SUMMARY OF PLANNING COMMISSION APPROVALS**FOR CAMERON STATION PHASES VI AND VII****TMP AMENDMENT**

Docket Item # 17
DEVELOPMENT SPECIAL USE PERMIT #2003-0018
CAMERON STATION PHASE VI

Planning Commission Meeting
November 6, 2003

ISSUE: Consideration of a request for a development special use permit, with site plan, for construction of townhouses.

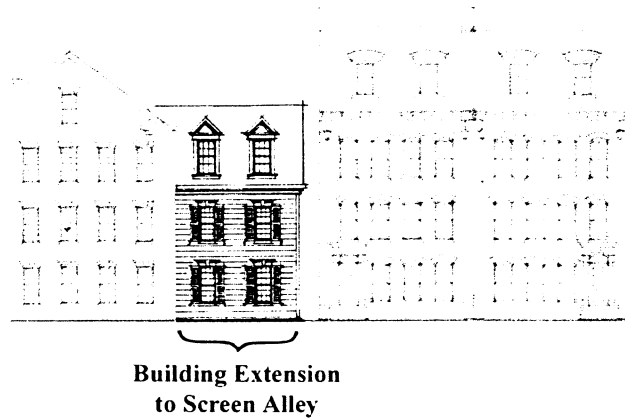
However, the landscape plan for phase VI requires a significant amount of additional refinement. While the plan proposes an adequate amount of tree canopy coverage, the design of the internal pocket parks spaces do not appear to follow a coherent scheme. Staff is recommending that the landscape design, particularly of the common spaces, be further developed in a coherent scheme to provide open space amenities that are comparable to the existing common space areas and pocket parks in the community. Staff is recommending that the lots adjacent to the pedestrian connections be reduced in size with property lines closer to the building footprint to ensure that the common open spaces and associated pathways are maintained as common areas for the community. Lastly, staff is recommending the applicant switch the townhouses proposed for lot 45 and lot 6 to provide an additional 2,000 square of open space in the eastern mews, and improve the space and the pedestrian connection through this mews.

One concern regarding street trees within Cameron Station has been providing adequate space for street trees adjacent to the front loaded units. A recommendation of staff is to provide an additional eight feet of front setback for the units adjacent to the linear park. This will enable the landscape area devoted to the street trees to be increased in sized from approximately 40 to 100 square feet and will also enable additional visitor parking in the front driveway.

Site Plan showing building extensions to screen alley

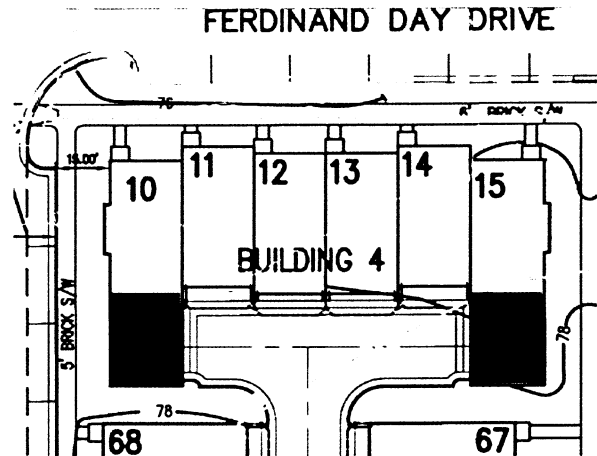
A concern that has been expressed about Cameron Station is that the alleys and the rears of the units are too visible from the streets. At the request of staff, the applicant has provided visual screening of the rear alleys and provided a more continuous streetscape adjacent to the streets by re-arranging the townhouses and extending the rears of six townhouses, similar to units that have recently been approved in Potomac Greens and Samuel Madden.

2. The configuration of the units shall be revised to provide the following:
 - a. Relocate the unit for lot 45 to lot 6 and for lot 6 to lot 45.
 - b. Units 1-3, 32-35 and 95-97 shall provide a minimum of 2-4 ft. setback from the adjoining units to provide building variation in the rows of the townhomes.

Site Plan Connections - Street Grid (Red), Sidewalks (Yellow) and Pedestrian Connections (Orange)

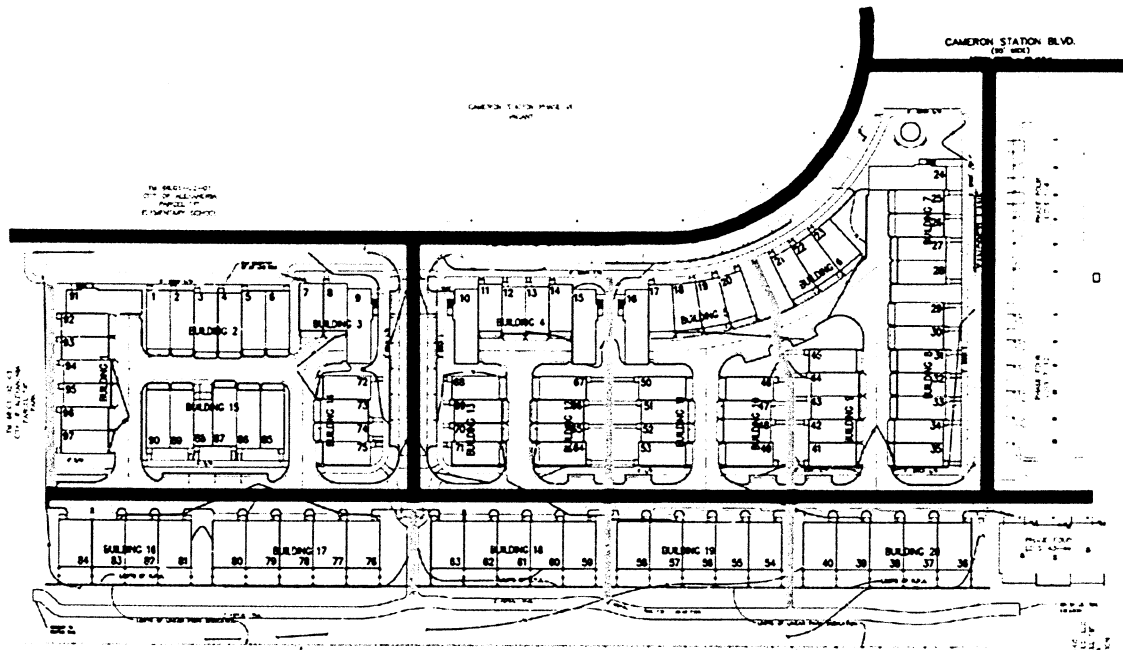
A primary concern with the previous proposal for the site was the large, uninterrupted buildings and the fact that the proposed development did not continue the existing modified street grid of Cameron Station. Therefore, from the initial concept meeting, staff has emphasized the importance of continuing the street grid and maintaining internal pedestrian connections to the linear park.

Cameron Station's street system, a modified grid, is a fundamental element establishing the scale and character of Cameron Station. The grid has not been perfectly applied as development on the site has progressed, but as the illustration below shows, the street grid within Cameron Station has fairly successfully broken the project into human-scaled blocks. And where a street has not broken down a block, a pedestrian connection/open space between buildings has generally completed the grid of openings and connections.

Through the concept review process and at the request of staff, the applicant has revised the plan to provide a street grid, internal open space areas, and pedestrian connections for the adjacent linear park. In addition to providing physical connections to the linear park and throughout Phase VI, these connections also provide visual breaks for the proposal.

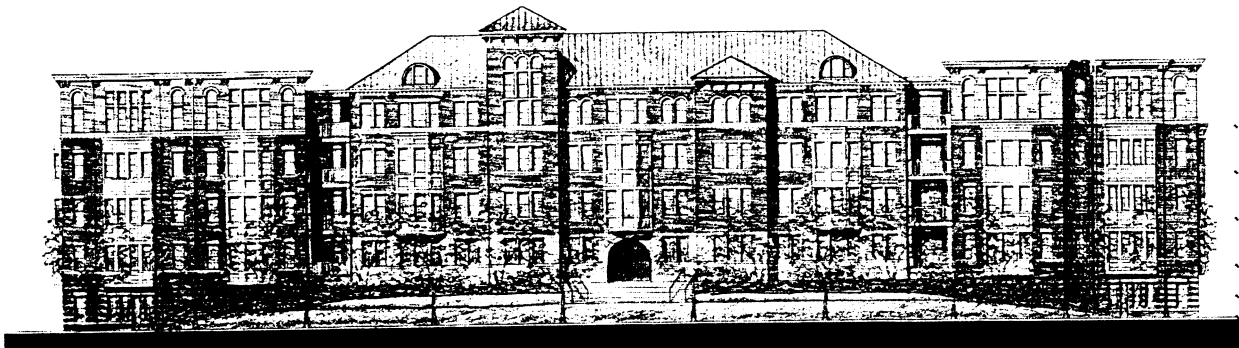
The height of the proposed building is approximately 60 feet, which provides an appropriate transition between the townhouses and elementary school adjacent to the site. However, the overall mass of the building, rather than height, has been a concern. Larger buildings can be designed in a manner that breaks the large mass and long facades into smaller components that will reduce the perceived mass. The original building design did not succeed in accomplishing this goal. To reduce the perceived mass of the building, staff has worked with the applicant to break the building into a series of vertical bays, recessed areas and to provide architectural treatment that will enable the building to appear as a series of smaller buildings, rather than one building.

The modifications recommended by staff included creating large recesses 30 feet wide and 20 feet deep along the north and south faces of the building to create a break in the continuous facade. Further breaks in the building face, recommended by staff and incorporated into the proposal, were in the form of recessed balconies, which provide breaks on all sides of the building.

The prominent location of this building necessitates that its design incorporate high quality materials and detailing. Therefore, a recommendation of staff is that the building be clad in masonry (brick, precast or stone). A recommendation of approval is the provision of variation in the building materials to create the perception of individual building elements through the use of contrasting brick colors and the use of precast concrete cladding in various parts of the bases of the building to make each of the elements appear as separate buildings. The variation in brick colors and the dark color hyphens between the separate “buildings” in addition to providing a strong building base of varying materials (precast and rusticated brick) will also help to visually divide the building into smaller elements.

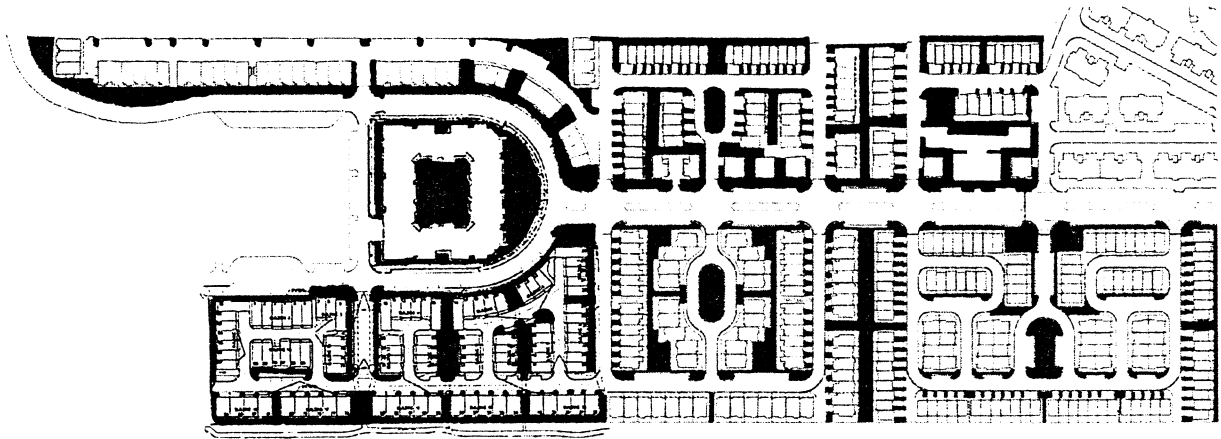
Finally, there are various recommendations made by staff to improve the scale and architectural quality of the project and its details which require additional refinement that include revising the arched passage on the east facade of the building to be treated as a full semicircle (instead of the segmental arch as shown), and the base story on the north and south elevations of the building should

be differentiated from the other parts by being clad in rusticated brick instead of precast. The rustication of the central portion of the building's east facade should be increased in height by a story to differentiate it from the corner massing elements.

Through the conceptual review process the applicant revised the overall design and roofline to provide the appearance of several smaller buildings which has been successful in reducing the perceived mass of the building.

Massing/Building breaks/roof form/tower/design

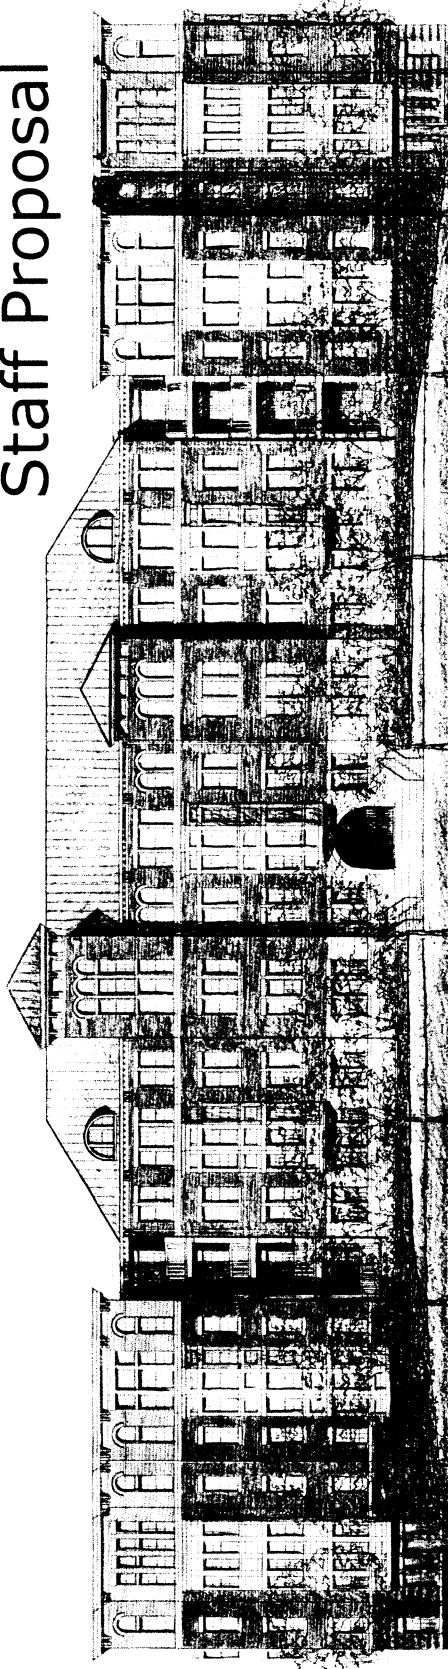
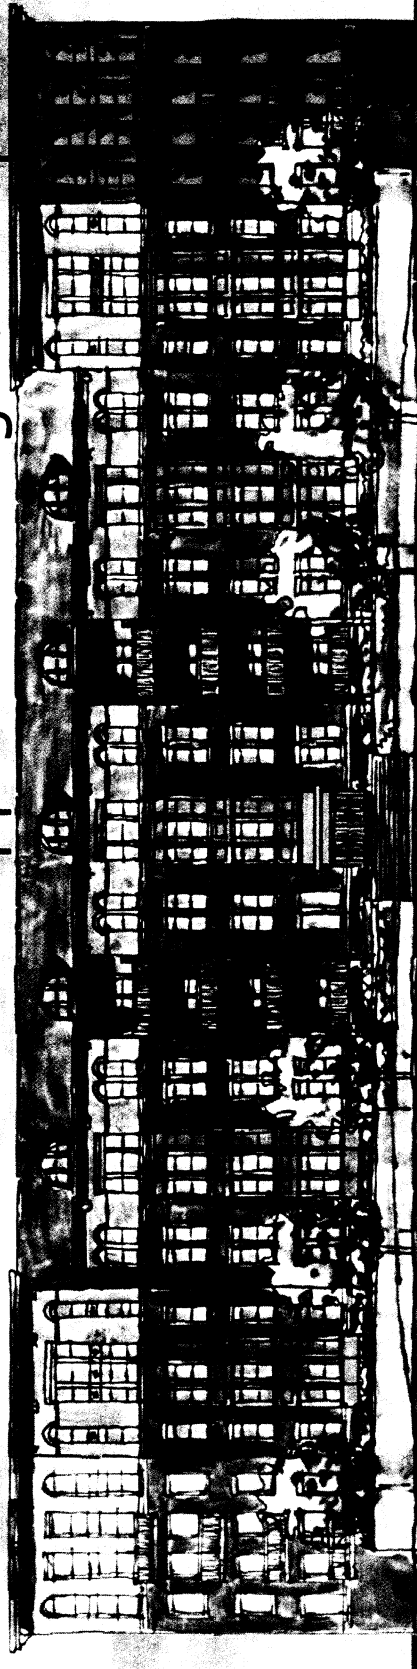
Staff Proposal

Applicant's Original Proposal
